BEFORE THE UNITED STATES
ENVIRONMENTAL PROTECTION AGENCY

IN THE MATTER OF THE PROPOSED)	COMMENTS OF UNITED PARK
LISTING OF RICHARDSON FLAT)	CITY MINES COMPANY IN
TAILINGS, SUMMIT COUNTY, UTAH,)	OPPOSITION TO PROPOSED
ON THE NATIONAL PRIORITIES LIST)	RULE

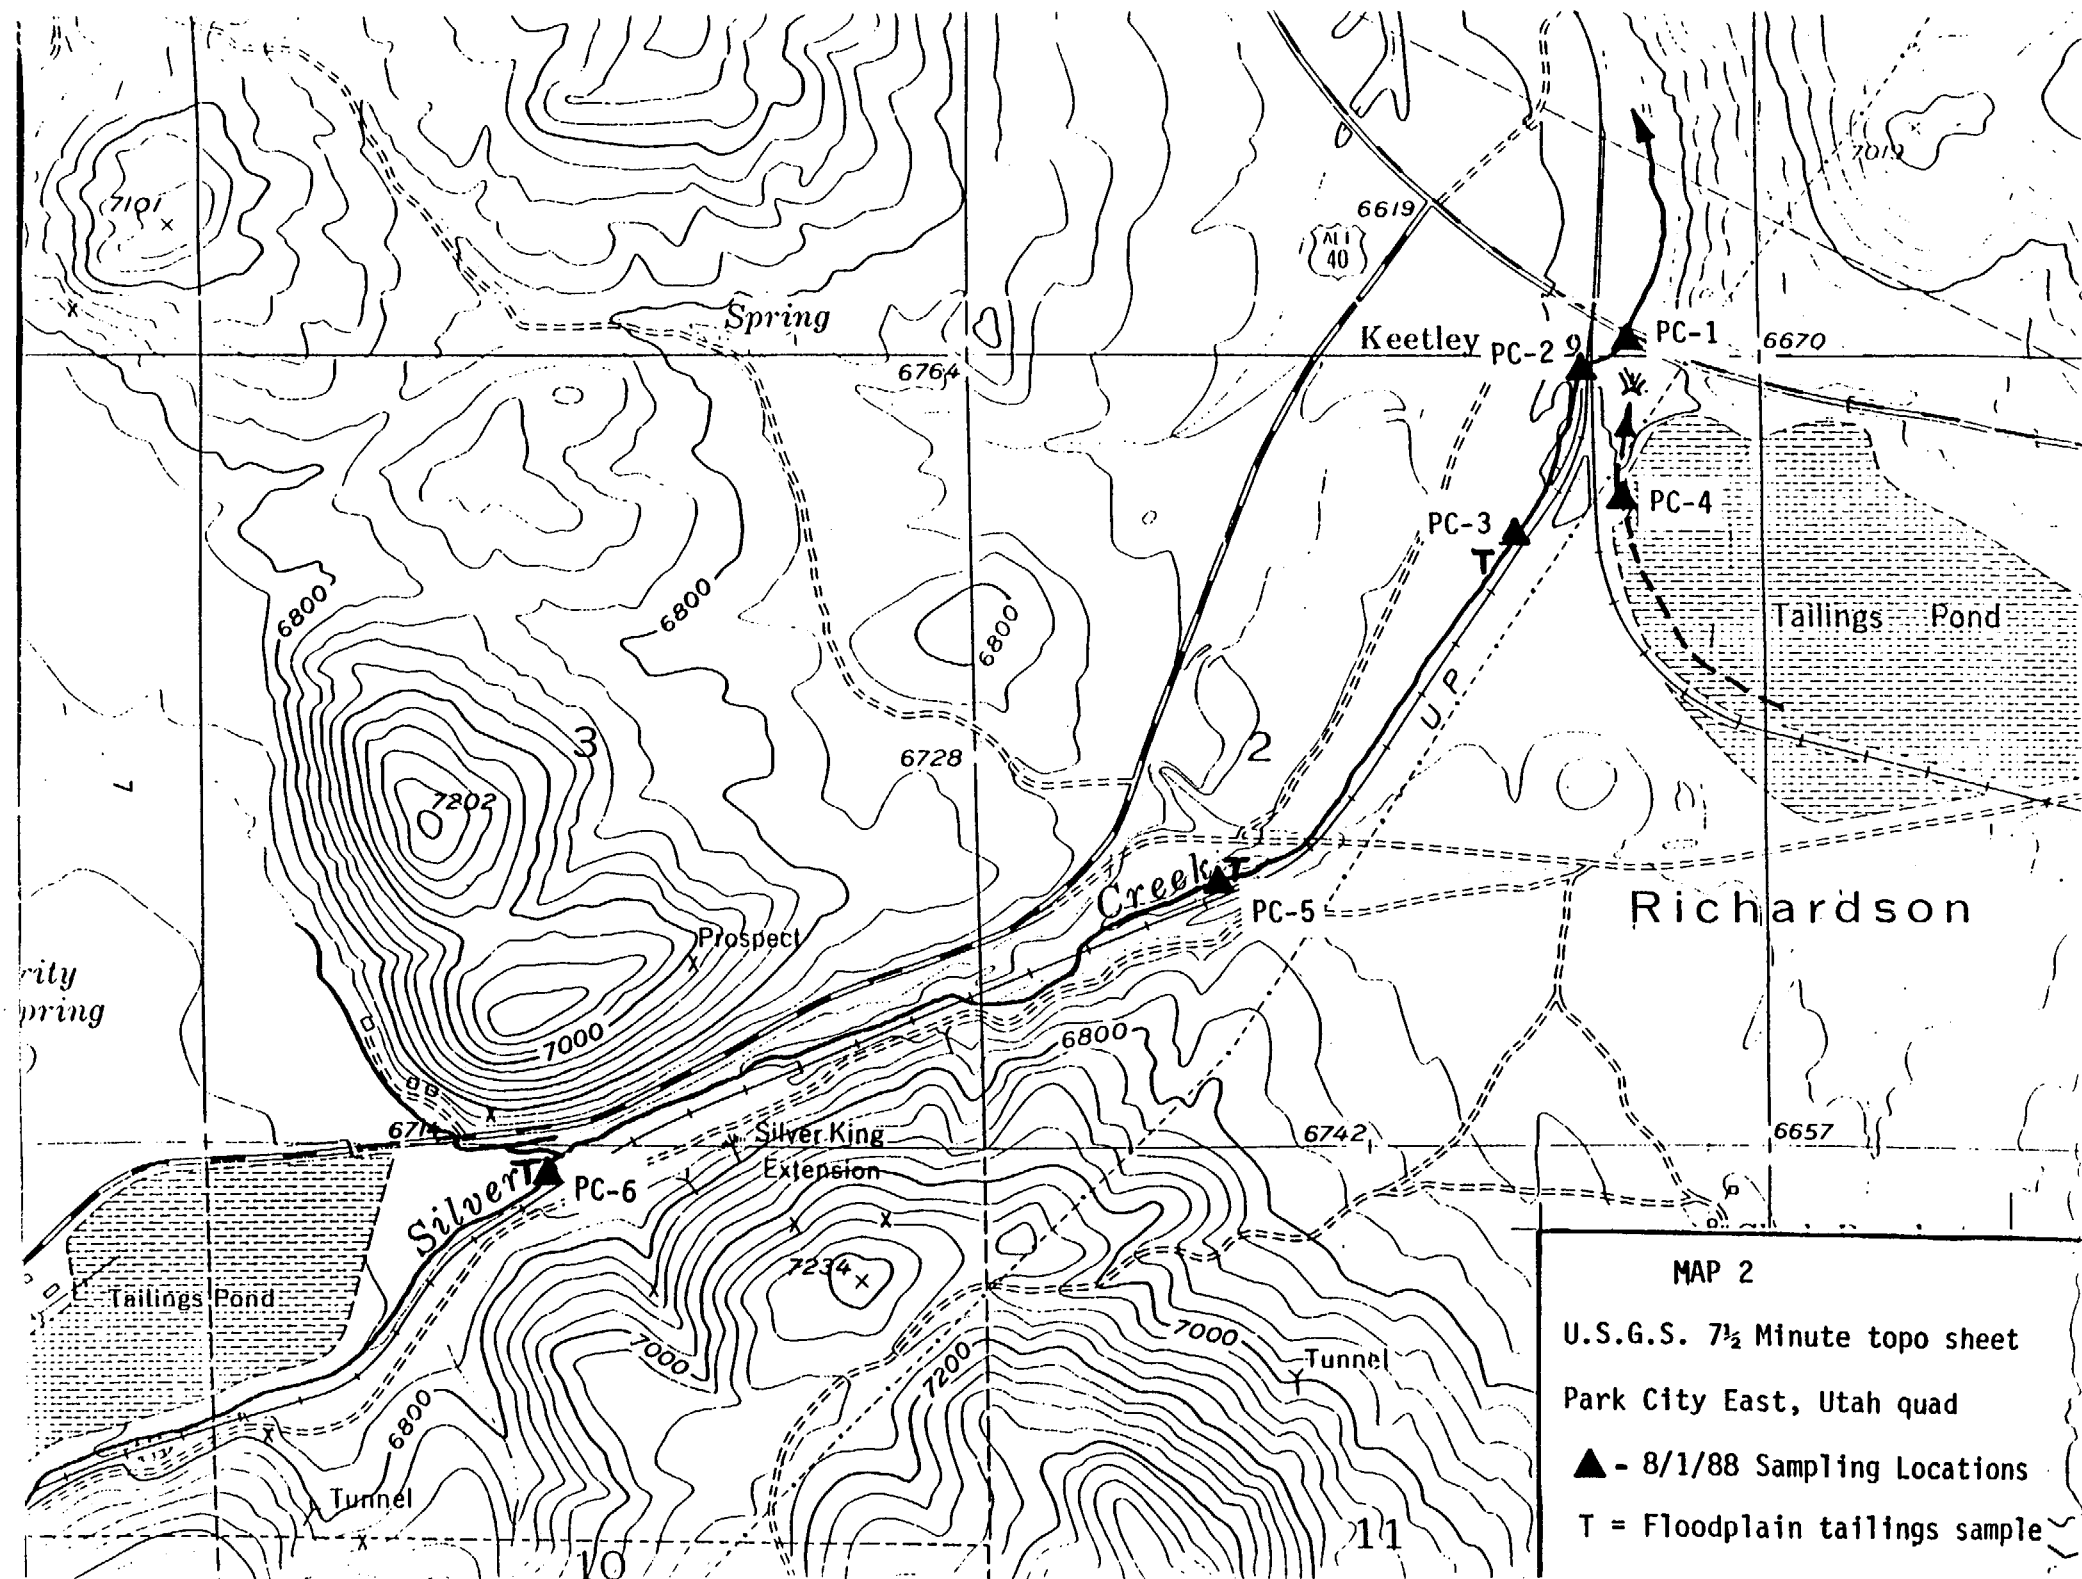
The NPDES data has been analyzed statistically using F-tests (analysis of variance) and T-tests (both the two-sample and paired-difference tests). These test results demonstrate conclusively that the upstream and downstream populations are indistinguishable from one another. The two-sample T-Test shows the means of the two populations (upstream and downstream) are not significantly different at the 99.5% confidence level. At the 94% confidence level, the variances are not significantly different either. The paired-difference T-Test shows the average difference between up- and downstream pairs is not significantly different from zero at the 98% confidence level. The mean difference is -0.0004 (upstream is higher). Hence, using existing NPDES data, there is no rationale for suspecting, much less scoring, an "observed release" to Silver Creek from the Richardson Flat tailings.

The difference found between RT-SW-1 and RT-SW-3 in E&E's 1985 sampling is most likely due to entrainment of particulate material from the banks and bedload of Silver Creek. A review of aerial photos, a ground check, and several samples (Map 2) confirm the floodplain downstream from Prospector Square is covered with stream deposited tailings.
